Discussion on “Coupled effective stress analysis of insertion problems in geotechnics with the Particle Finite Element Method” by L. Monforte, M. Arroyo, J.M. Carbonell, and A. Gens

Abstract

Fig. D1. PWP distribution around the piezocone: ALE model (frictionless interface) and corresponding SCSEM results. [no colour]

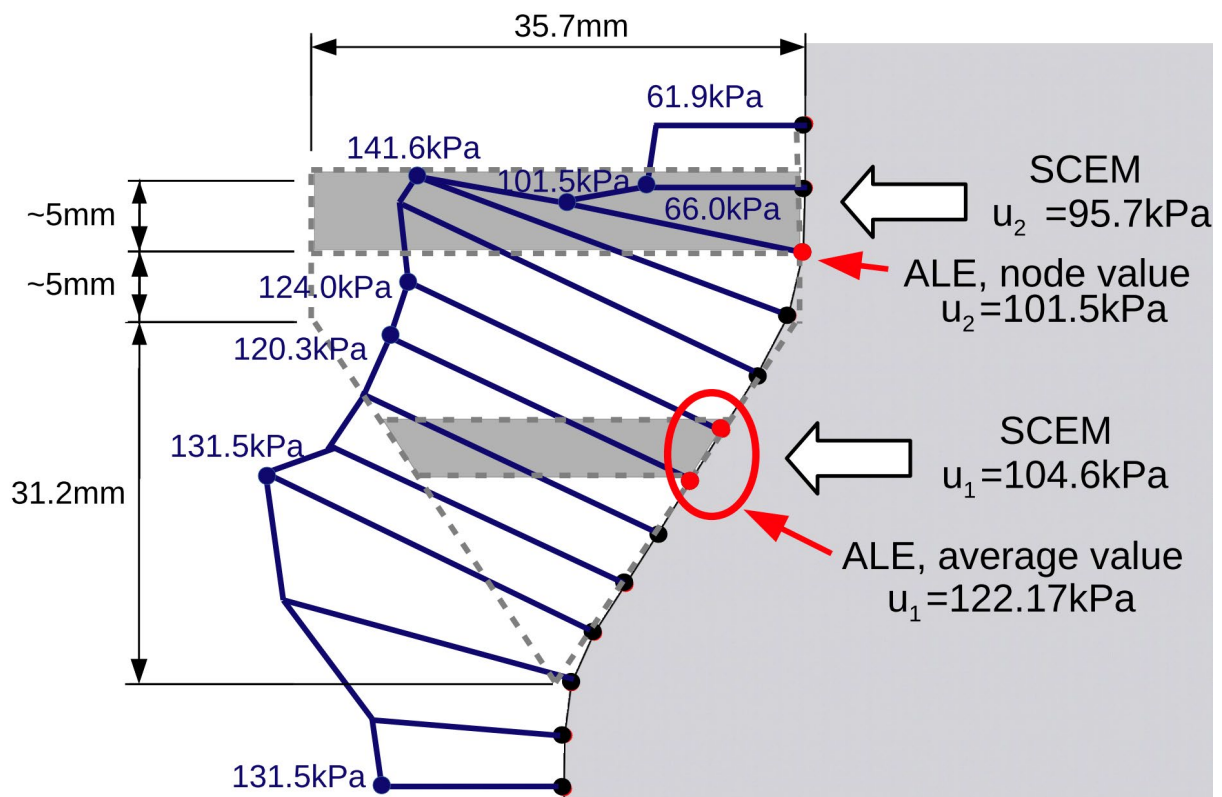
where: u = pore water pressure around the cone, Δu_{oct} = octahedral component of pore water pressure, Δu_{shear} = shear-induced component of pore water pressure, Δu_{TSP} = total stress path dependent component of pore water pressure, s = total stress path coefficient ($s=4/3$ for u_1 and $s=0$ for u_2 [6]), u_0 = initial pore water pressure, K_0 = earth pressure at rest coefficient, σ'_{v0} = initial effective vertical stress. Using compatible parameters ($G=877.32\text{kPa}$, $c_u=17.78\text{kPa}$) and initial conditions assumed by the Authors (weightless soil, $p'_0=38.57\text{kPa}$, $K_0=0.5$), one can calculate the corresponding components of the mobilized excess pore water pressure: $\Delta u_{oct}=92.70\text{kPa}$, $\Delta u_{shear}=3.01\text{kPa}$, $\Delta u_{TSP}=8.84\text{kPa}$ (only for u_1) and $u_0=0\text{kPa}$ (due to weightless soil). Consequently, the water pressures at the filter positions are $u_1=104.55\text{kPa}$ and $u_2=95.71\text{kPa}$. With $G=1306.32\text{kPa}$, one obtains $\Delta u_{oct}=101.86\text{kPa}$, $\Delta u_{shear}=3\text{kPa}$, $\Delta u_{TSP}=8.84\text{kPa}$, $u_1=113.71\text{kPa}$ and $u_2=104.86\text{kPa}$. These values are significantly lower than those presented by the Authors in Table 4. In Discussers' opinion, this could be attributed to high oscillations and variability of PWP distributions around the cone obtained with LDFEM, such as UL, ALE, MPM or PFEM. Examples of such non-uniform distribution can be seen in the Authors' papers (Fig. 8b in [2], and Fig. 2 in [8]). In Fig. D1, the Discussers present the PWP distributions around the cone from the ALE model (frictionless interface) and the corresponding SCEM solutions for u_1 and u_2 . The concentration of generated PWP is observed at the cone tip and just behind the cone. The Discussers predominantly used the average PWP value from the u_1 area (see Fig. D1). For the u_2 position, the Discussers mainly considered the PWP values close to the actual filter position or the average value from nearby points, see Fig. D1. However, due to high PWP fluctuations in this area, it is difficult to determine the actual u_2 value. This high variability is also observed for field registered u_2 measurements (e.g., Fig. 2 in [9]) or lab tests (e.g., Table 2 in [10]). To sum up, due to uncertainty in determining u_2 , the unique reference SCEM solution may facilitate the

interpretation in the cone vicinity. Discussers would like to ask the Authors for their opinion regarding the reliability of u_2 output in PFEM.

Fig. D2. Effect of interface friction on (a) cone resistance and (b) sleeve friction. [no colour]

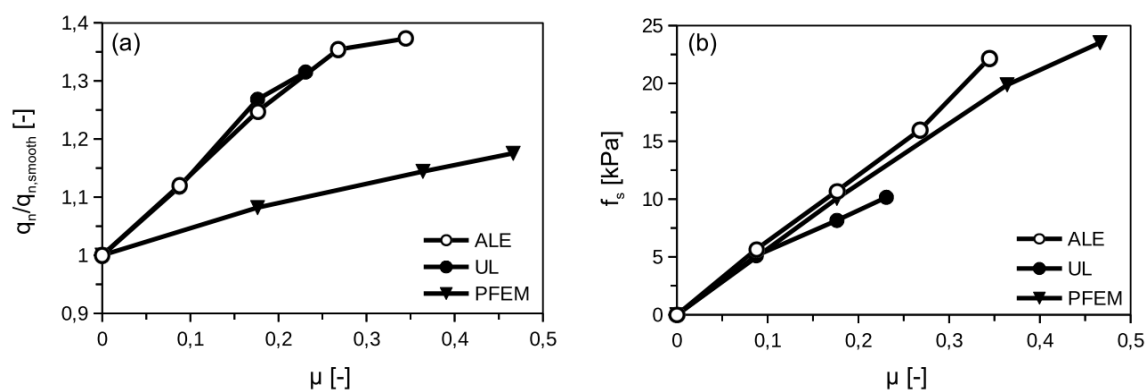
The q_n increase with interface friction is presented in Fig. D2a. The numerically simulated q_n obtained using ALE and UL is up to 40% higher than for the corresponding smooth cone and

considerably higher than the PFEM solution. The Authors suggest that PFEM and MPM give similar results when there is an increase in interface friction. They link the discrepancies with the performance of contact algorithm, although both formulations use the contact penalty method. The ALE and UL calculation results presented by the Discussers are closer to the MPM solutions [3] referred by the Authors. This may suggest that the friction component of the cone resistance is underestimated in the PFEM.

Fig. D2b presents sleeve friction increase in relation to interface friction. Here, UL, ALE, and PFEM give almost the same results. However, this to some extent contradicts the cone resistance results (Fig. D2a) and the Discussers would like to ask the Authors for their opinion regarding the contact algorithm performance.

Fig. D3. Effect of interface friction on PWP at (a) u_1 , (b) u_2 and (c) u_3 . [no colour]

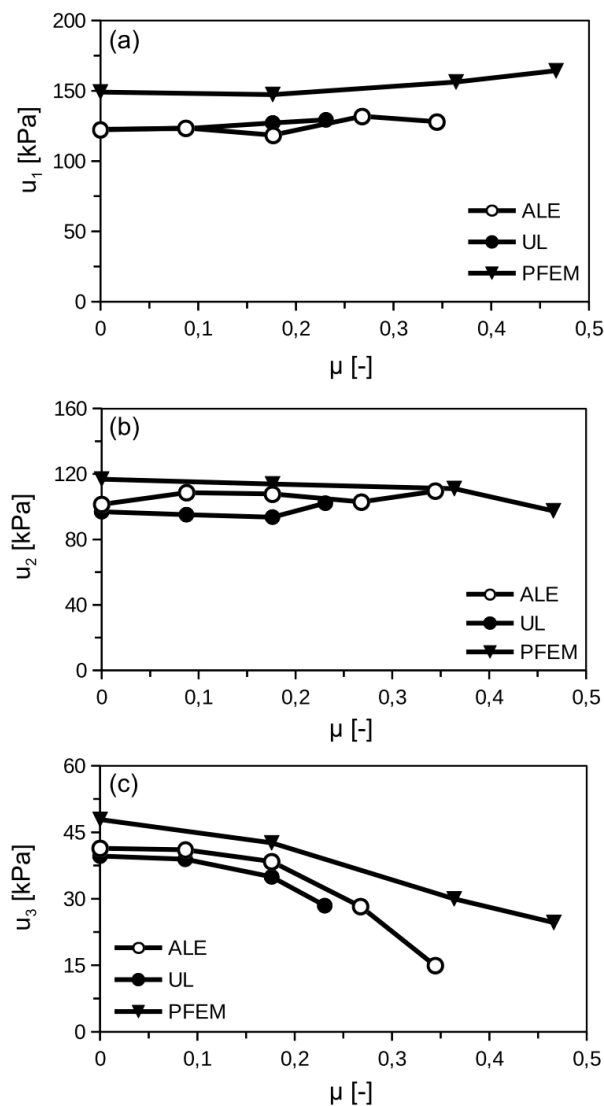
The Authors' analysis of pore water pressures developed around the cone due to different interface friction seems to be incomplete. Of the provided values u_1 , u_2 and u_3 (in Table 4), only the results of u_2 position are discussed. A comparison between the Authors' and the Discussers' results is presented in Fig. D3. The discrepancies for the u_2 position may be related to the PWP nodes used in the analysis. This issue was already addressed in section 2. The PWP around the cone (in u_1 and u_2) seems to be independent of the interface friction. The

research shows that only the u_3 position seems to be slightly influenced by interface friction when $\mu < 0.2$. For higher μ values, this effect is more important.
